STAFF REPORT - TOWN OF NORTH CASTLE PLANNING DEPARTMENT
February 7, 2022

APPLICATION NUMBER - NAME #2022-003 – 9 Cole Drive - Daniel Accessory Apartment Special Permit and Site Plan Approvals	SBL 94.02-1-12
---	-------------------

To: Town of North Castle Planning Dept

Re: 9 Cole Dr – Section 94.02 Block 1 Lot 12

PROPOSED SITE CONDITIONS PLAN

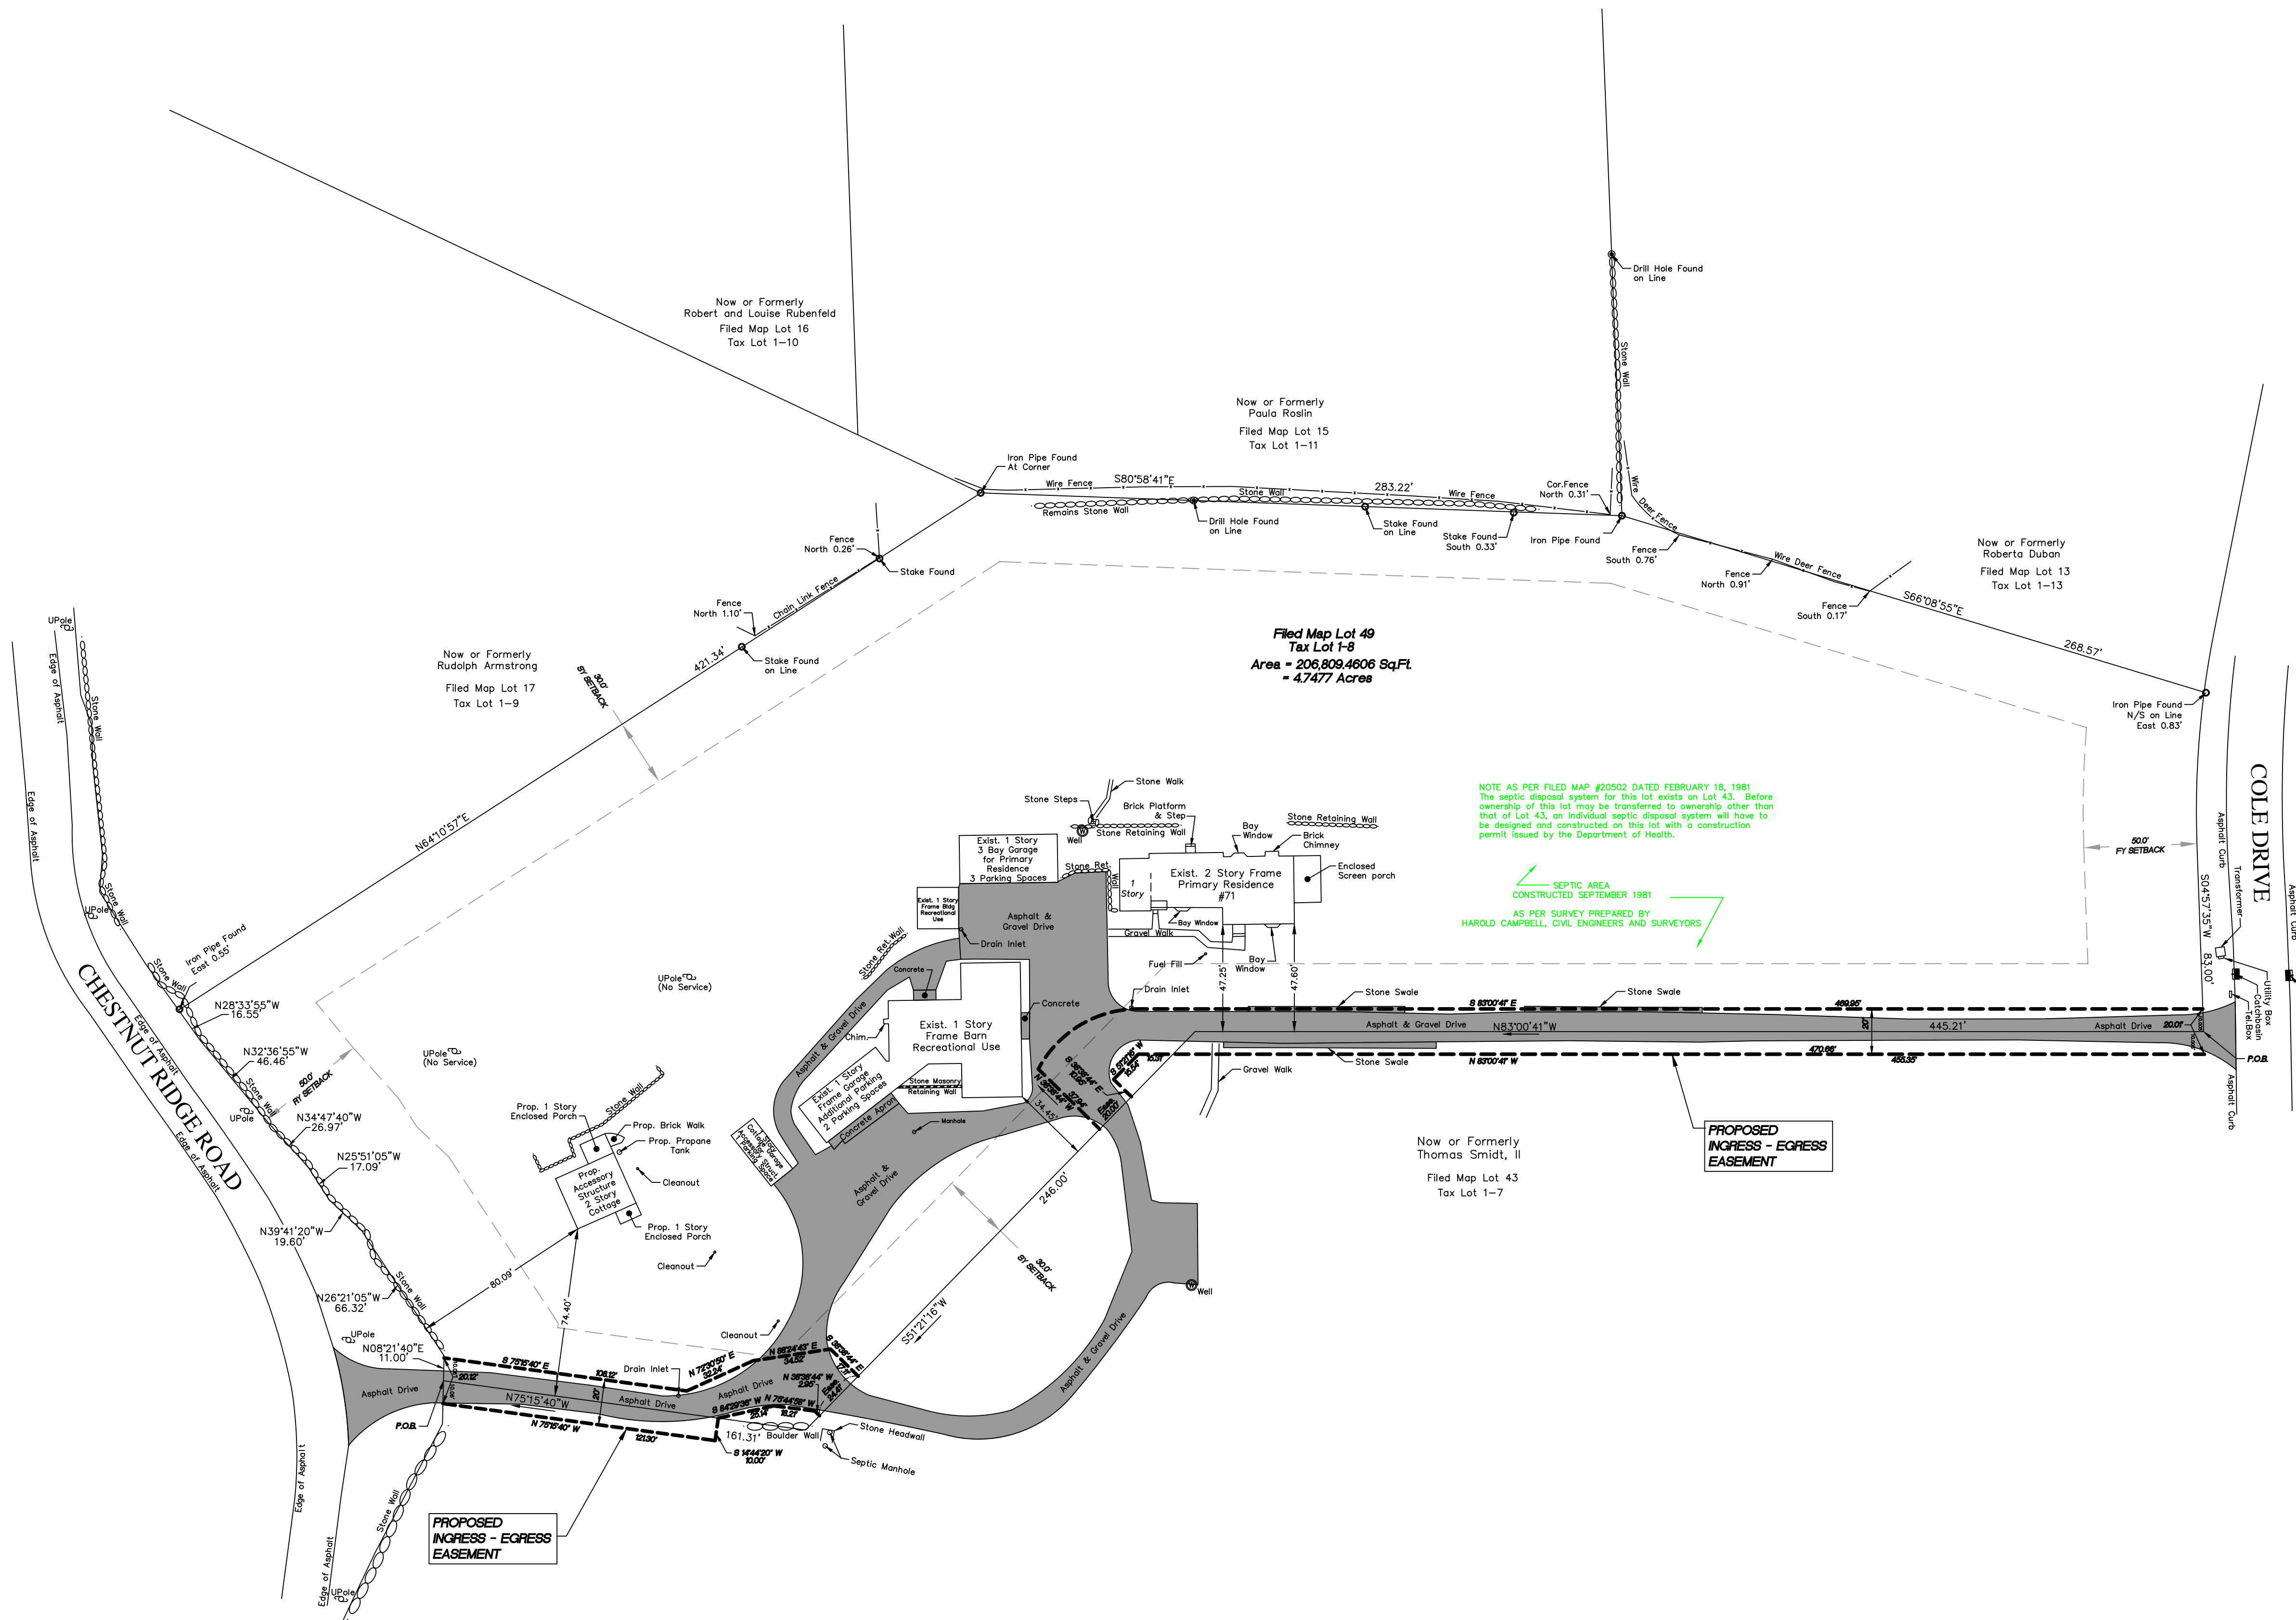
1. The submitted site plan depicts several buildings on the site; however, the use of each structure is not identified. The site plan should be revised to depict all existing and proposed uses of each structure.
The uses of each building are now labeled on the site plan.

2. The site plan depicts two lots (94.02-1-12 & 94.04-1-2). Since lot 94.04-1-2 is not part of this application, the site plan shall be revised to eliminate the depiction of this lot in the submission materials.
The limits of lot 94.04-1-2 is no longer shown on the site plan, however, the driveway and small structures remain depicted on the site plan for clarification purposes.

6. Pursuant to Section 355-40.K(8) of the Town Code, any principal or accessory building in which an accessory apartment is proposed shall meet all applicable setback requirements and other standards for the district in which it is located.

8. The site plan should be revised to depict the location of off-street parking for the principal dwelling (2 spaces) and for the accessory apartment (1 space).

The site plan now shows the standard setbacks for the district (R-2A) it's located within.

The "1 Story Cottage Garage for Accessory Struct. 1 Parking Space" has been labeled on the site plan showing the location of off-street parking for the accessory structure, and the "Exist. 1 Story 3 Bay Garage for Primary Residence 3 Parking Spaces" has been labeled on the site plan showing the location of off-street parking for the primary structure.

PROPOSED SITE CONDITIONS PLAN

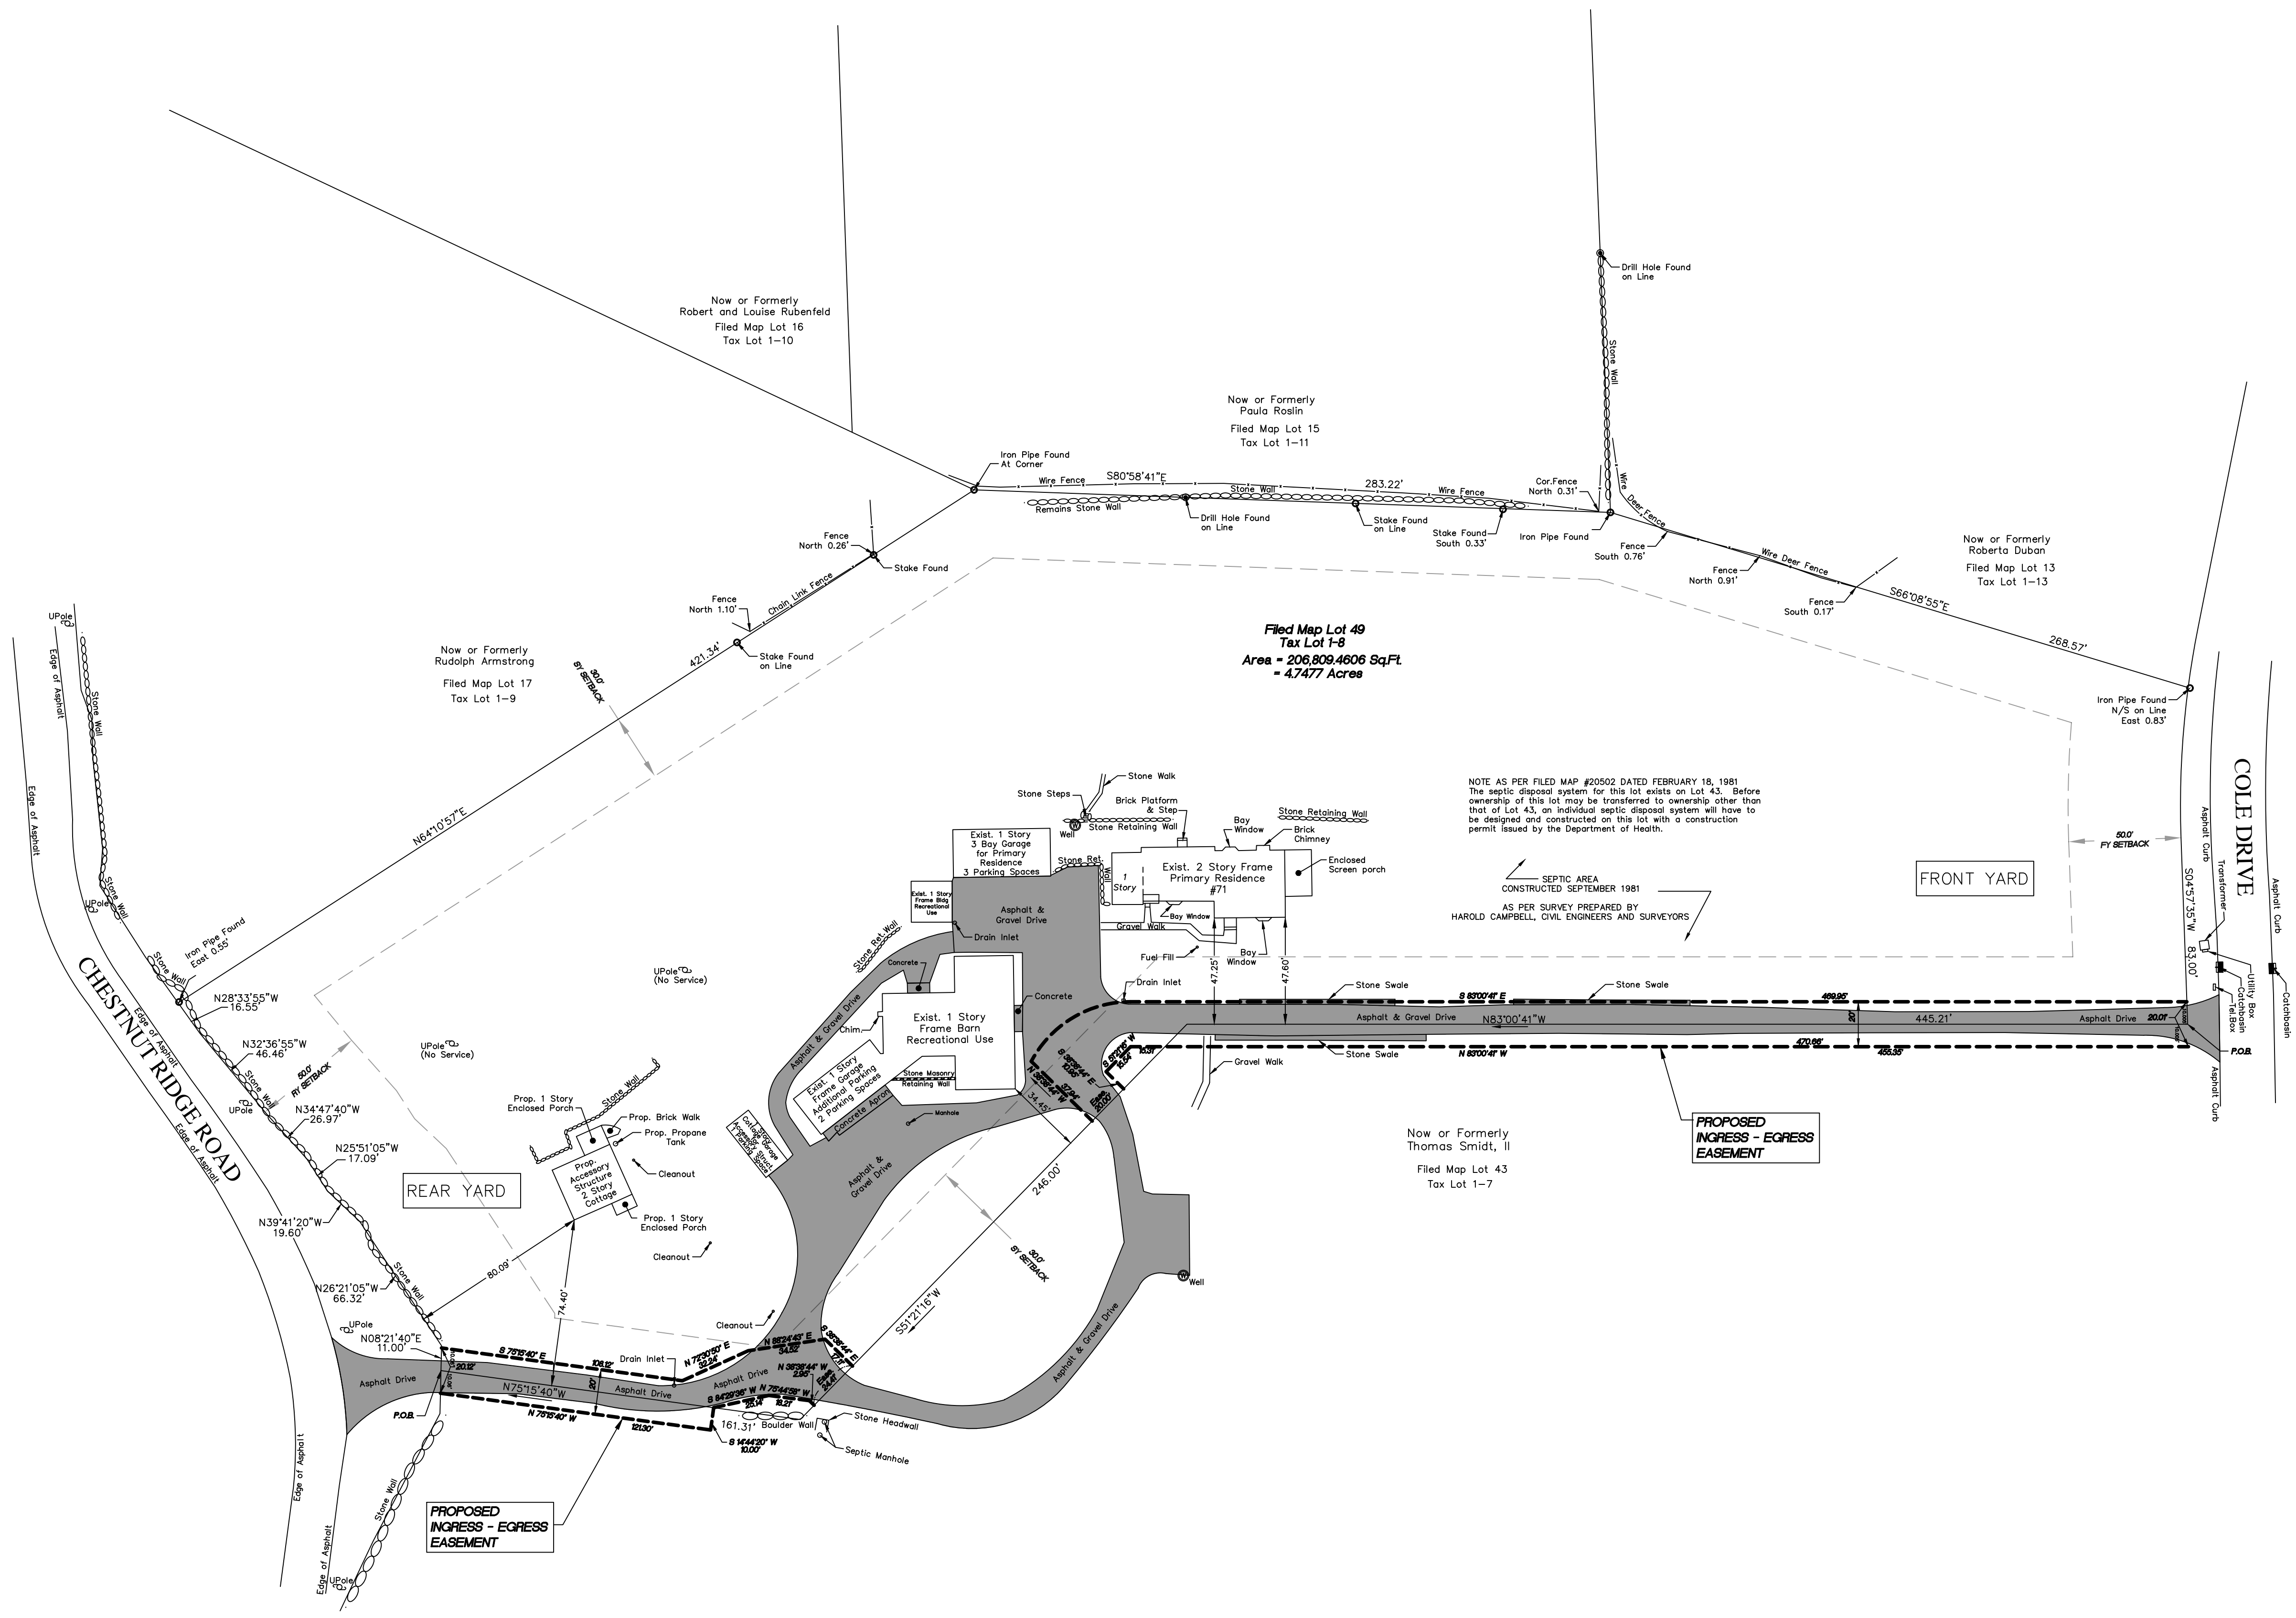
REV.	DESCRIPTION:	BY:	DATE:
1	LABEL FRONT YARD & REAR YARD	GC	01/10/23
rev	description	by	date
REV:	DESCRIPTION:	BY:	DATE:
